TECHNICAL SERVICE BULLETIN

Lack Of Air Flow/HVAC Blower Motor Inoperative

23-2288

Ford 2021-2023 E-Series

Figure 6

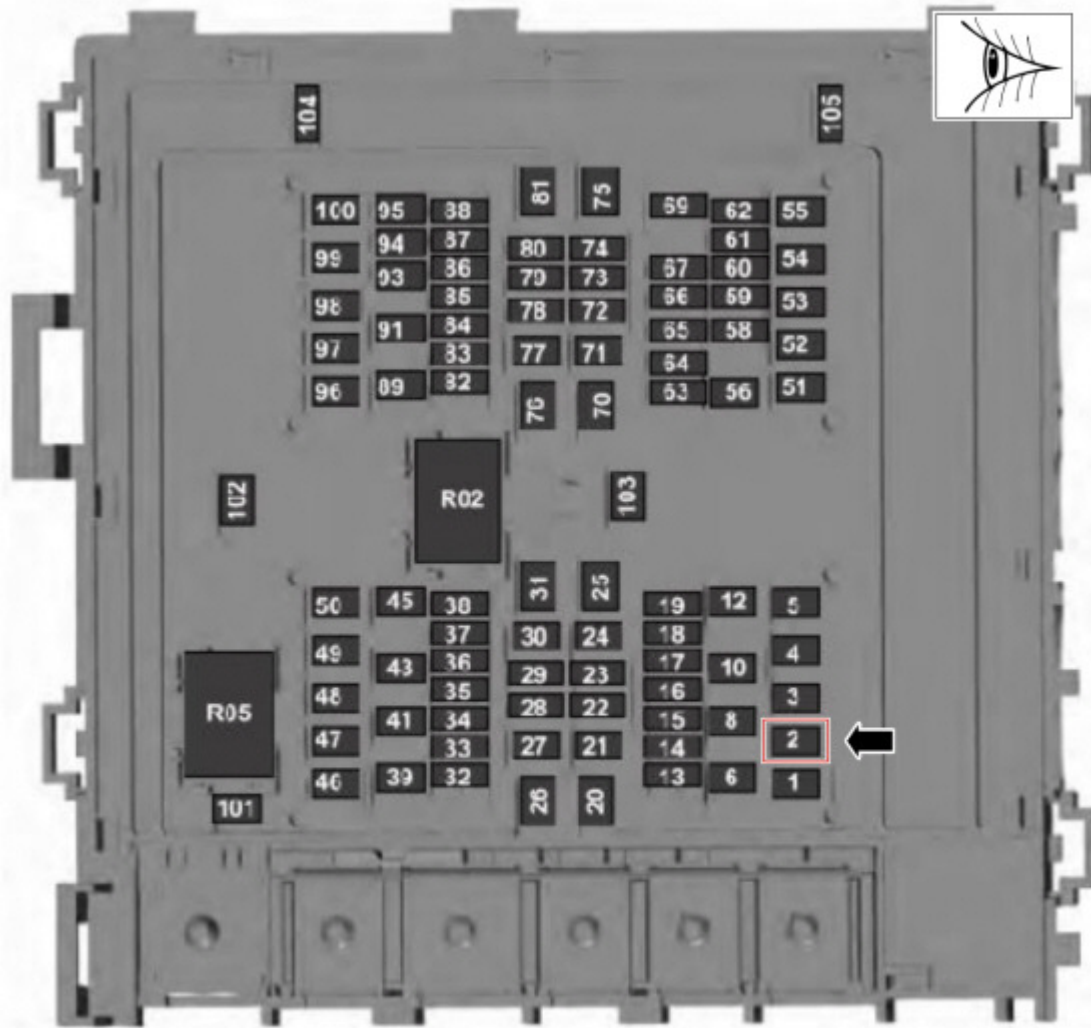
6. Repair or replace connector C1035B. Refer to Wiring Diagram, Cell 005 for repair procedures.
7. Replace the BJB reversing the removal procedure.
8. Remove fuse F2 and replace with the listed service replacement part. (Figure 6)
